**WEST SUSSEX COUNTY COUNCIL
STRATEGIC PLANNING CONSULTATION**

SUBJECT: A/23/15/OUT – Hybrid application – Full Planning Permission for a retail unit (Class A1) comprising 1,487sqm (1022sqm ground floor and 465sqm mezzanine) with associated access, car parking, servicing, landscaping & associated works. Outline Planning Permission for a public house (Class A4) comprising 581sqm at ground floor level – This is a Departure from the Development Plan

Land south of New Road (A259) and East of Brook Lane, Angmering

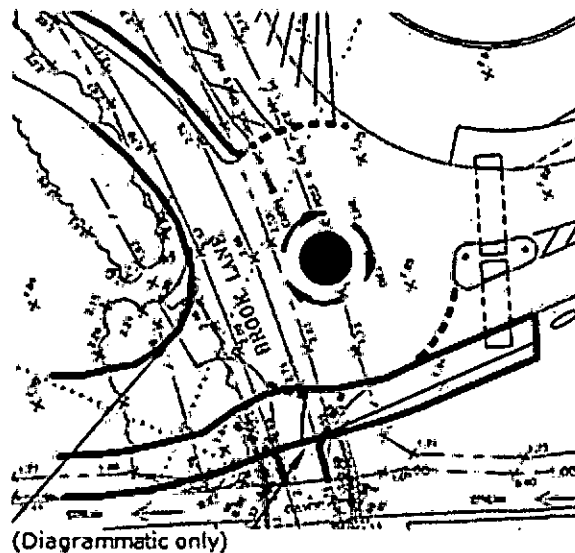
Two Departure from Standard (DfS) applications were submitted in July, in relation to the entry corner radius and the length of the acceleration lane as previously requested. Although these have now both been approved as per the attached documentation, a revision to the design means that the acceleration lane length now meets the required standard. In order to achieve this, the nose ahead of the merging taper that was previously 40m has been reduced to 35m. DMRB TD 42/95 explains that a nose of 40m may precede the merge and it is considered that 35m is therefore acceptable.

In relation to the deceleration lane and diverge DfS, this has been signed off on the basis that a 43m increase in the deceleration lane length is provided to allow a comfortable additional deceleration down before the 20m diverge radii. The need for this extension has been calculated on the basis of the recorded 85th percentile vehicle speeds.

- The merge lane alongside the splitter island needs to increase to 6.5m width with hatching by reducing the splitter island slightly to ensure maintenance is possible without closure, and allowed continued operation in the event of a breakdown.
- Please show the forward visibility splay alongside the splitter island on the merge
- It is felt that Brook Lane arm of the mini-roundabout could be better served as a crossover. This would then mean the roundabout would become three arm with the future development site to the west (see below suggestion). If the design does change, the swept path analysis will need to be updated.
- Speed reduction measures should also be considered along the private car park access.
